ORDINANCE NO. 5088

AN ORDINANCE APPROVING A TENTATIVE SUBDIVISION FOR A 280 LOT, PHASED SINGLE-FAMILY DETACHED RESIDENTIAL DEVELOPMENT AT THE NORTHEAST QUADRANT OF THE INTERSECTION OF NW HILL ROAD AND NW BAKER CREEK ROAD

The Planning Department received an application (S 1-19) from Stafford Development Company, LLC requesting approval of a Tentative Subdivision (more than 10 lots) for a 280 lot, ten phase single-family detached residential development; and

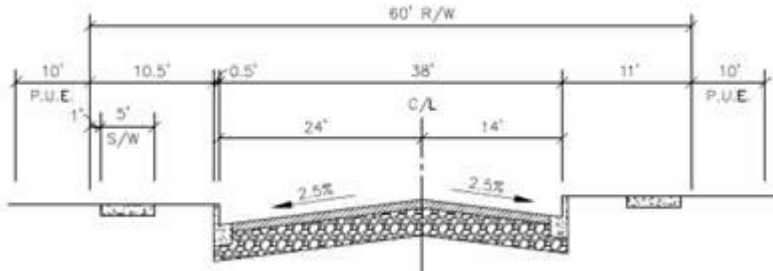
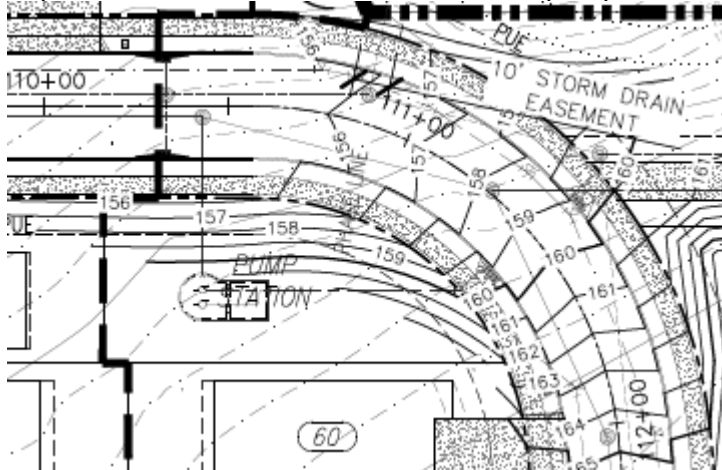
- The proposed intersection of Gregory & Augustine Streets shall be redesigned such that the intersection angle is as near to 90° as practical. The current "Y" configuration is not consistent with MMC Section 17.53.101(F):

- MMC 17.53.101(O) indicates that the public alley in the City's street standards applies to commercial and industrial districts, not to residential developments. Thus, the proposed alleys on the proposal shall be private, and shall be maintained by the adjacent property owners or the Home Owners Association.
- Meadows Dr and Shadden Dr are proposed to have an offset crown to accommodate a right turn lane (see cross-section below). We would prefer see the City's typical "Teepee" section so that the curb elevations match on each side of the street.
